STAFF RECOMMENDATION 1700 Dorothy Place March 18, 2015

Application: New construction-infill
District: South Music Row Neighborhood Conservation Zoning Overlay
Council District: 19
Map and Parcel Number: 10408031100
Applicant: John Root, RootArch
Project Lead: Paul Hoffman, paul.hoffman@nashville.gov

<p>Description of Project: The applicant proposes to construct a two-story office building facing Dorothy Place. A five foot (5') setback reduction is requested for Dorothy Place and a ten foot (10') setback reduction is requested for the rear alley.</p> <p>Recommendation Summary: Recommends approval with the conditions:</p> <ul style="list-style-type: none"> • Windows on the Seventeenth Avenue South and Dorothy Place facades be redesigned to meet historic rhythm and spacing of openings; • Staff recommends administrative review of materials; and, • Utilities be located on the alley or along the shared property line, beyond the midpoint of the building, from Seventeenth Avenue South. <p>With these conditions, Staff finds the project to meet the design guidelines for New Construction in the South Music Row Neighborhood Conservation Zoning Overlay.</p>	<p>Attachments A: Photographs B: Si

1 17TH AVE. S. ELEVATION

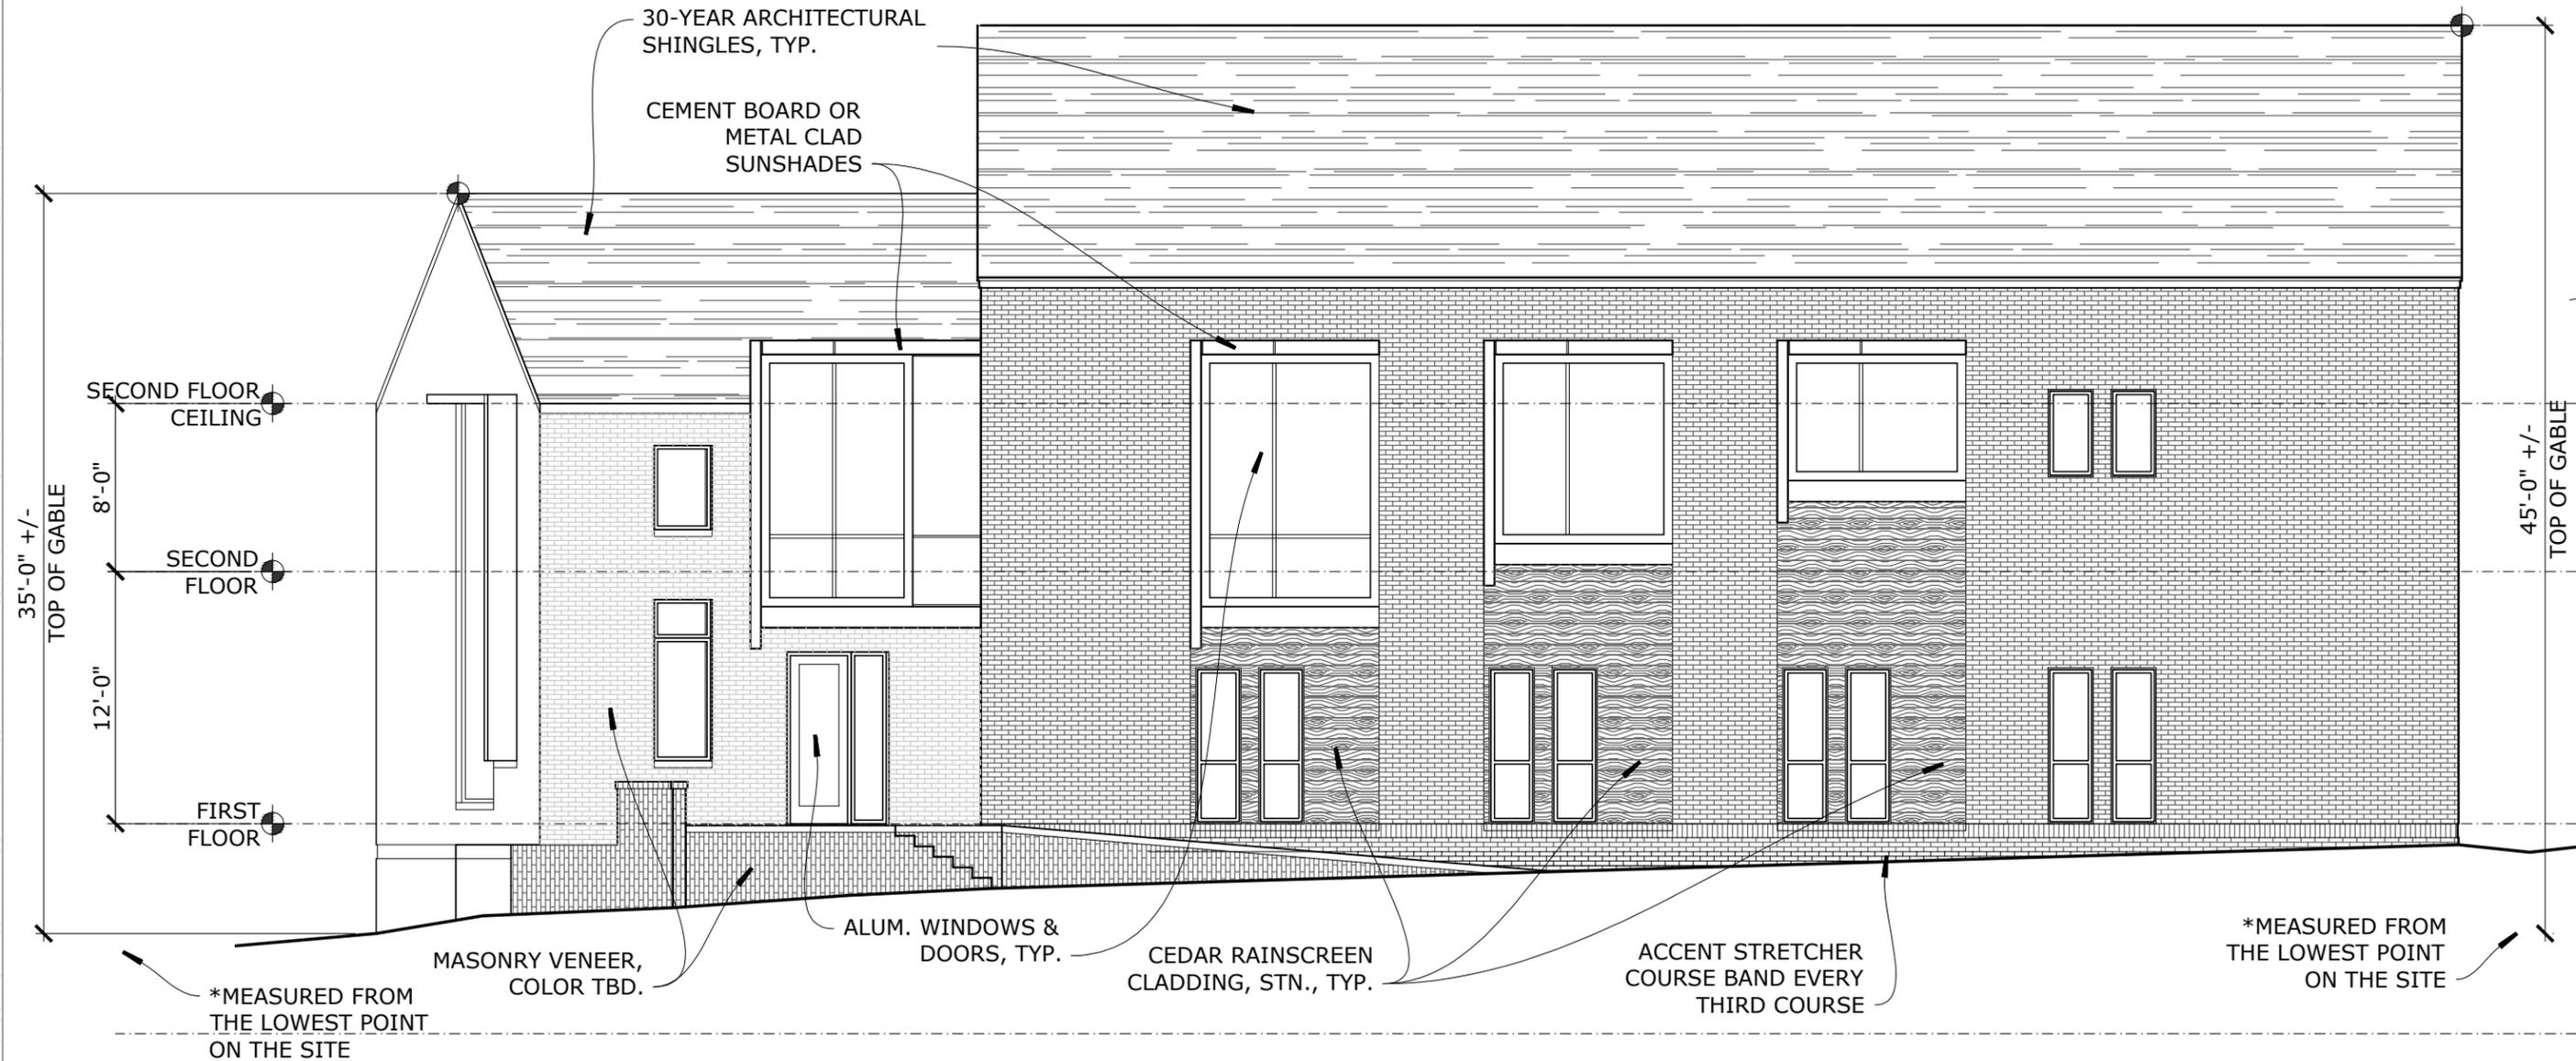
Proportion and Rhythm of Openings: The proportion of historic windows is 2:1 and they are generally regularly spaced with up to eight to thirteen feet (8'-13') between openings. In addition, historic windows were usually the same height on each floor or the first level windows were taller due to the first level ceiling heights being taller. The proposed windows on the Seventeenth Avenue South and Dorothy Place elevations vary greatly in proportion and spacing. There is as much as twenty-one feet of one side of the Dorothy elevation without an opening. With the exception of those windows closest to Seventeenth Avenue South, the windows on the north and alley elevations will be minimally visible from the public right-of-way. Staff finds that the windows on the Seventeenth Avenue South and Dorothy Place do not meet section II.B.1.f.

- Windows on the Seventieth Avenue and Dorothy Place facades be redesigned to meet historic rhythm and spacing of openings;
- Staff recommends administrative review of materials; and,
- Utilities be located the utilities be located on the alley or along the shared property line, beyond the midpoint of the building, from Seventeenth Avenue South.
